S.Suhi Industrial Park Ltd. (New Building)

4th February 2018

Observations: Sweater Building

Floor Layout Plan

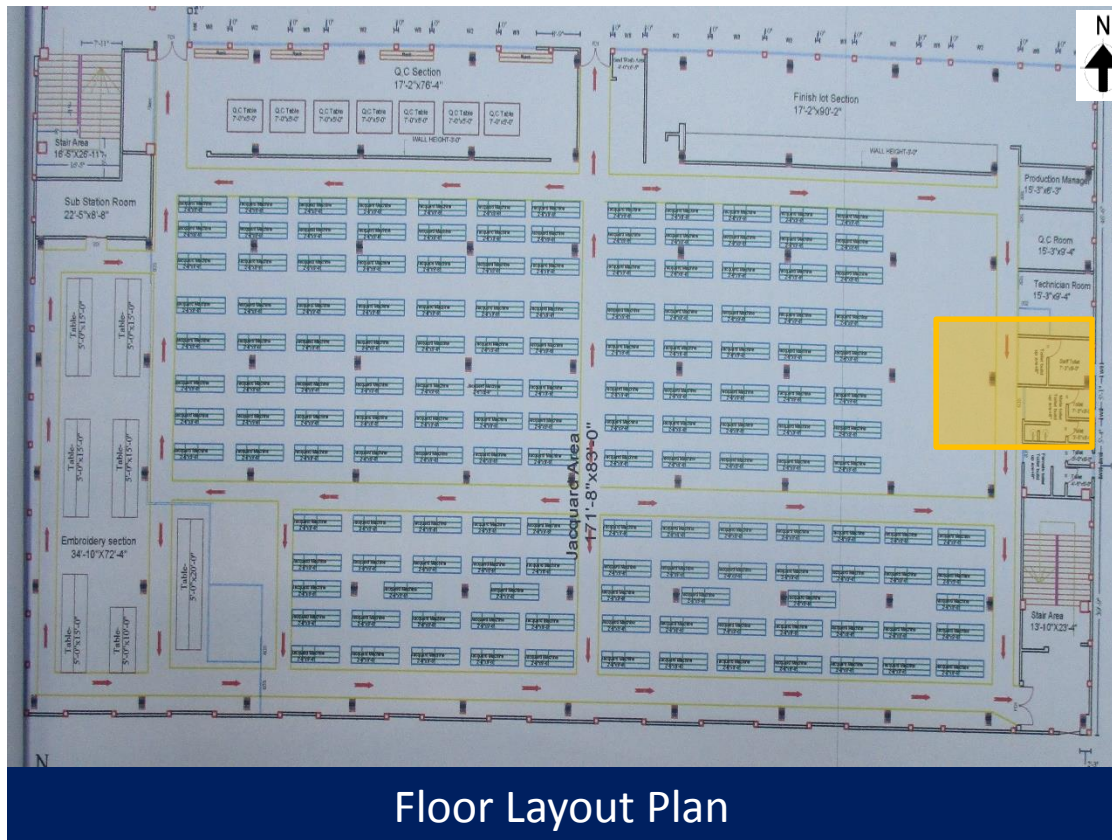
Steel columns to be stressed above normal design limits

Cursory calculations indicate that the working stress of the highlighted columns at ground floor level appear to be stressed in excess of normal design limits.

Column Layout Plan

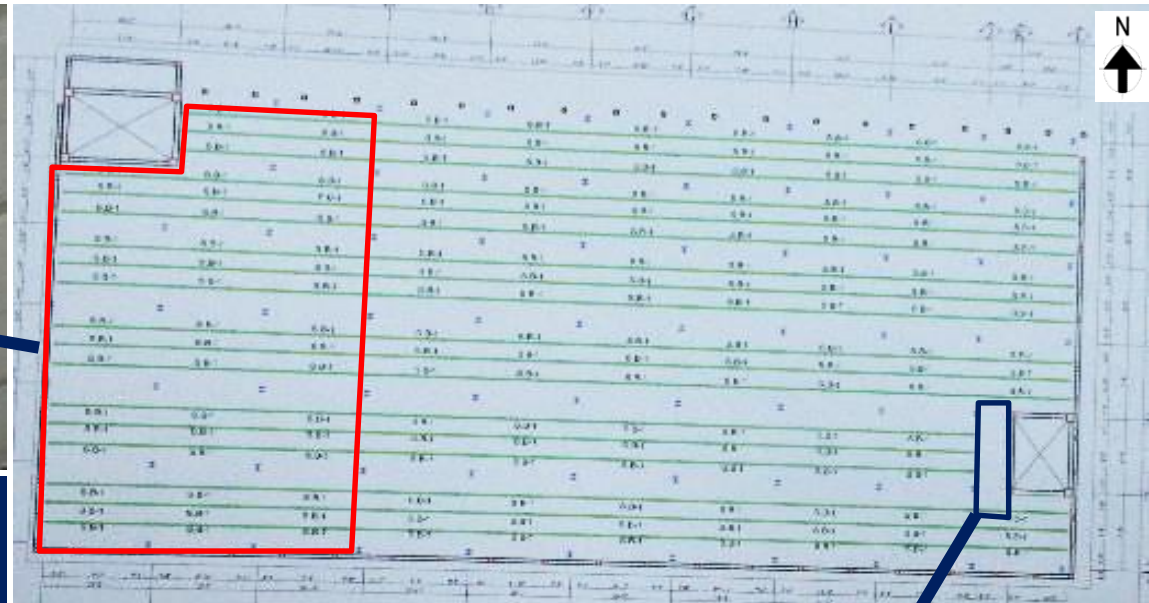
Depth of web was observed 315 mm instead of 325 mm

During inspection, Steel section of the highlighted columns were found undersized at ground floor and 1st floor level.

Width of flange of the highlighted portion was observed 150 mm instead of 175 mm.

Sub- Beam Layout Plan

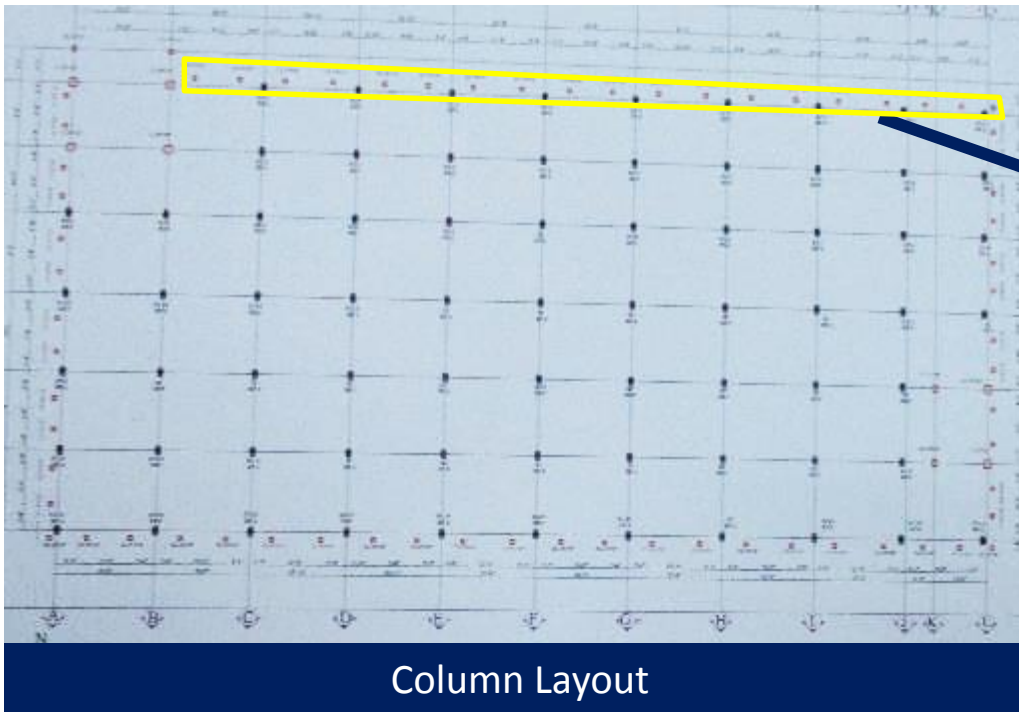
During inspection, Steel main beam and sub-beam were found under-sized of the highlighted portion at 1st floor and 2nd floor level. Also some sub-beams near north-east staircase were not indicated in sub-beam layout plan.

Steel Sub Beam was observed on the highlighted portion at ground floor roof which was not included in As -Built drawing.

Column Layout

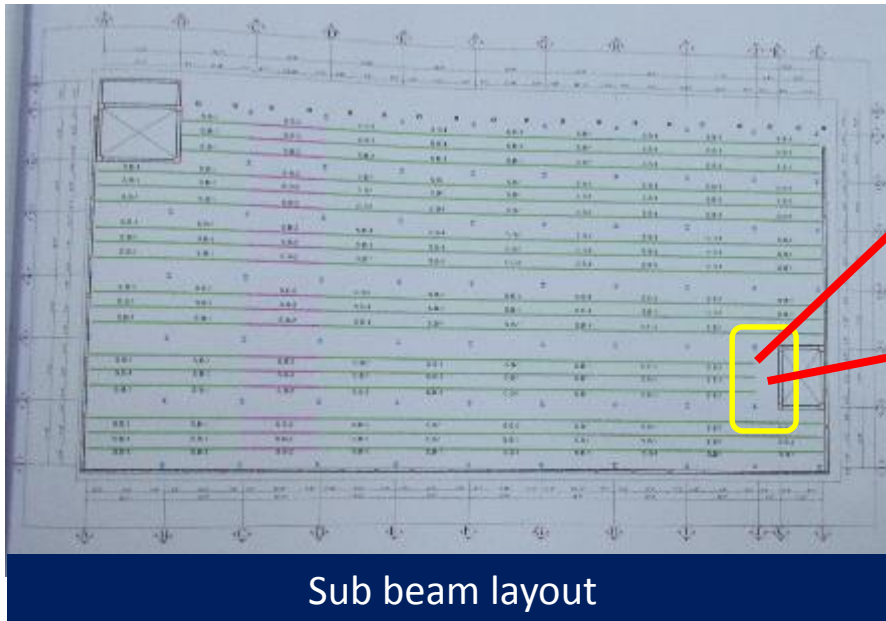
In drawing, RCC columns were mentioned on ground floor for the highlighted portion. But Brick columns were observed on site.

Sub beam layout

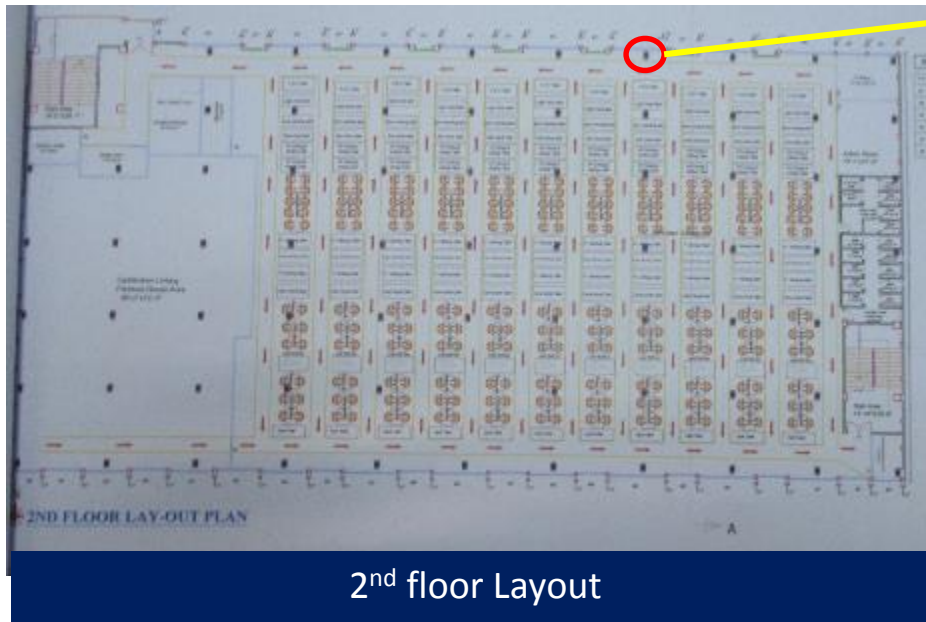
Almost 5 feet width deck slab found near Eastside stair without sub-beam on 1st, 2nd and 3rd floor. Factory engineer is required to confirm that deck has adequate capacity to take the floor load otherwise provide additional beams.

Deck without sub-beam

2nd floor Layout

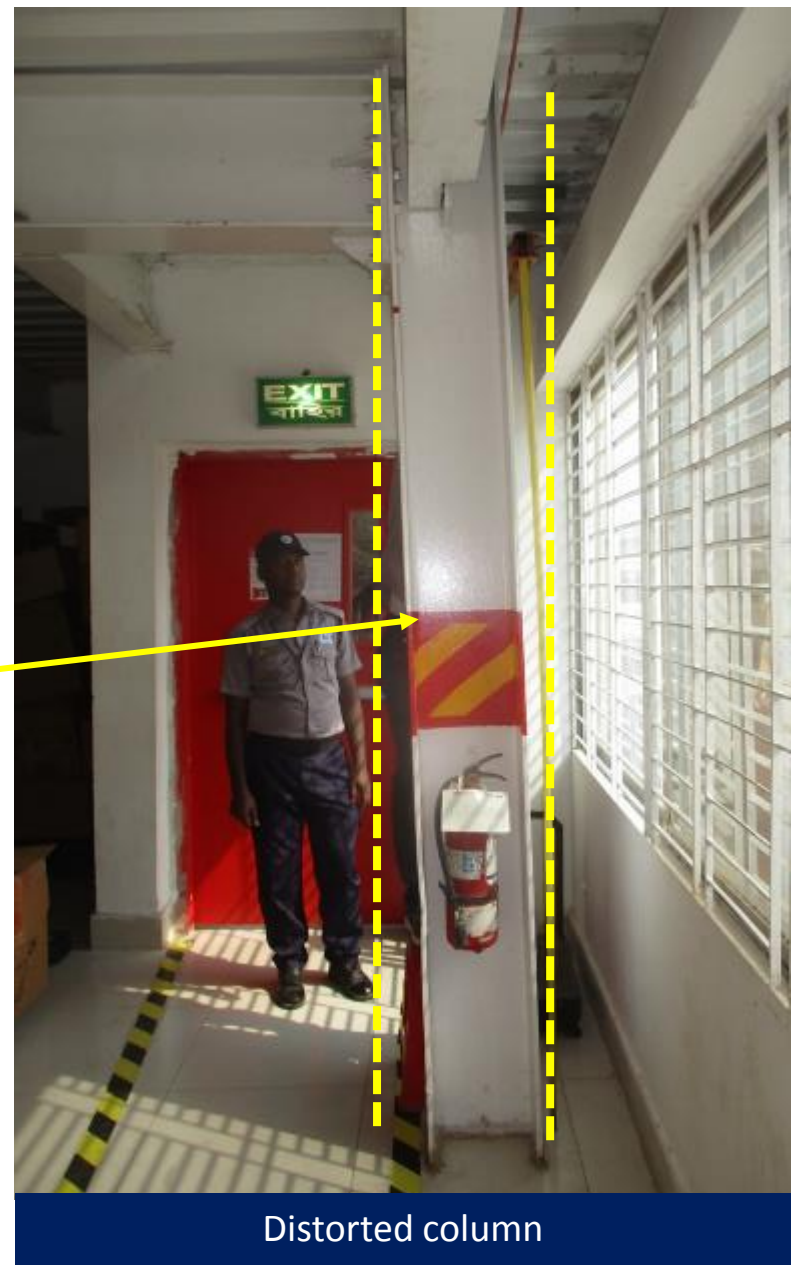
A distorted steel column found on 2nd & 3rd floor of the main production building. Stability for the distorted columns and related elements need to be checked. Factory Engineer to review design, loads and column stress in the area identified above.

Distorted column

Elevation

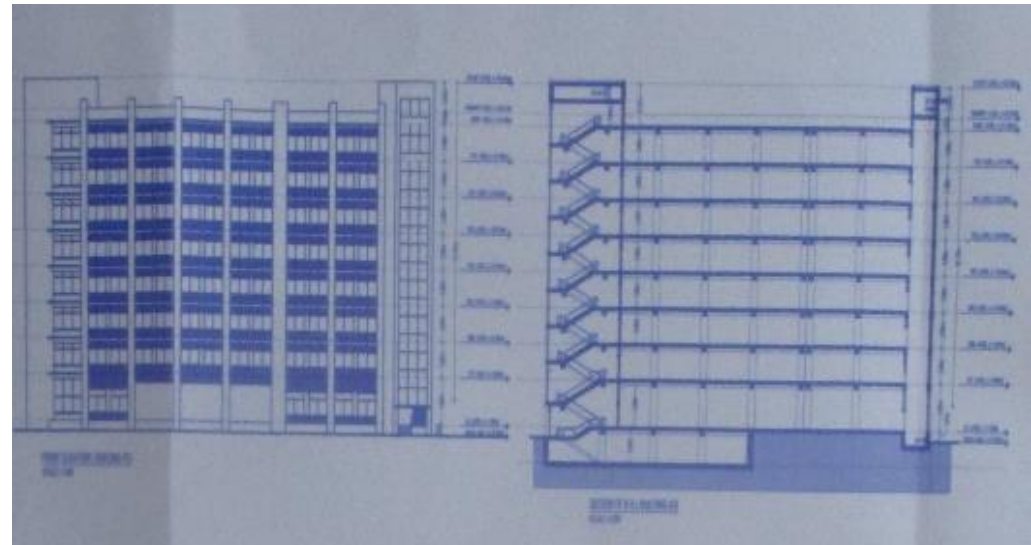
Currently the building is 4 storied. There is a possibility of one storey extension in future. Factory engineer is required to carried out a Detail Engineering Assessment considering BNBC provision prior to commencement of any extension work.

Local authority Permit drawing shown 6 storied

Ground floor roof.

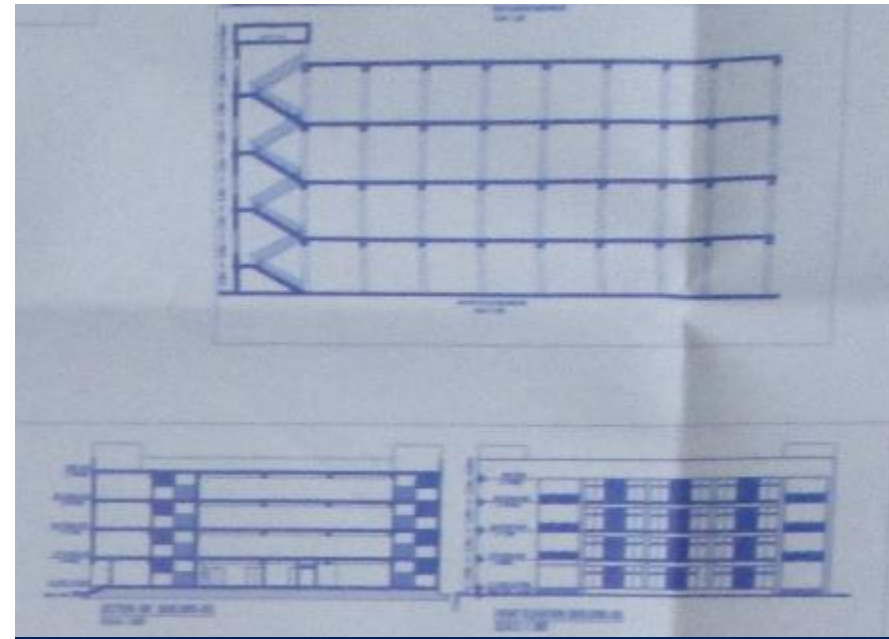
Exposed rebar and stacking of construction material at roof

Currently the exposed reinforcement is prone to corrosion. All exposed reinforcement must have adequate protection. There is no parapet on first floor which may cause falling hazard. Also, stacked materials need to be removed from roof and develop proper drainage system.

Stacked materials.
